Product Change Notification

Change Notification #:	112502 - 00
Change Title:	Intel® PRO/1000 PT Dual Port Server Adapter (Redwater) SKU EXPI9402PT MM#868973 Retail PCN 112502-00 Label Update UPC & EAN codes on the Outer Box Label (OBL)
Date of Publication:	August 22, 2013

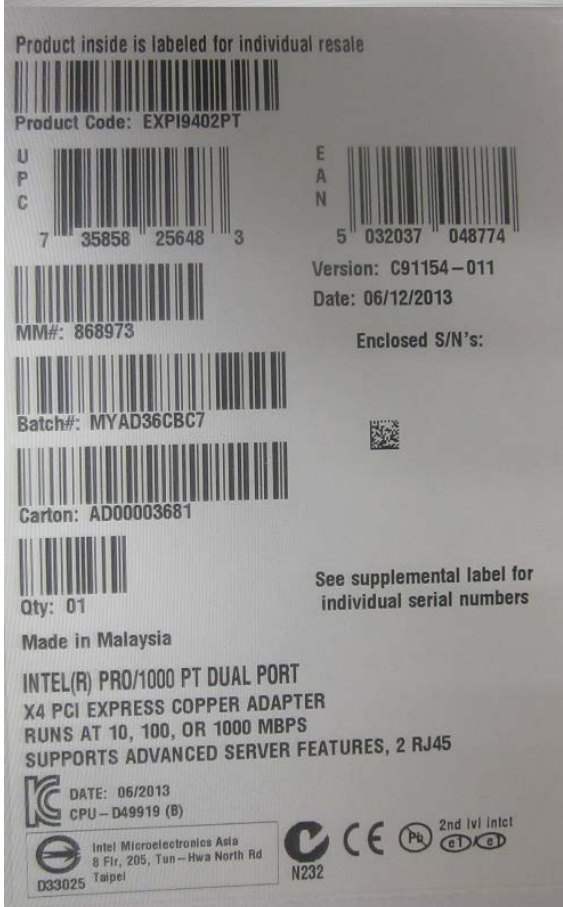
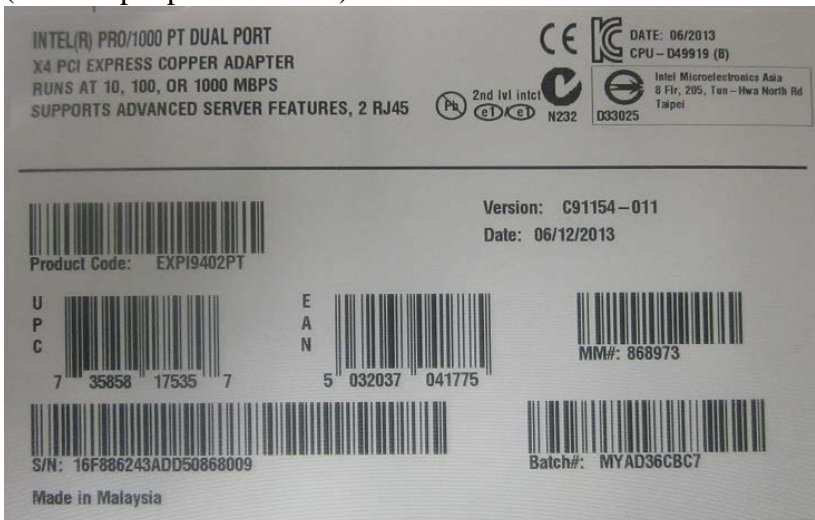
The Intel® PRO/1000 PT Dual Port Server Adapter will undergo the following changes:

1. The UPC and EAN codes on the retail single box label will be updated to:

Product Code	MM#	Disti UPC	Disti EAN	OBL UPC	OBL EAN
EXPI9402PT	868973	735858273985	5032037058605	735858175340	5032037041768

(See sample photos below)
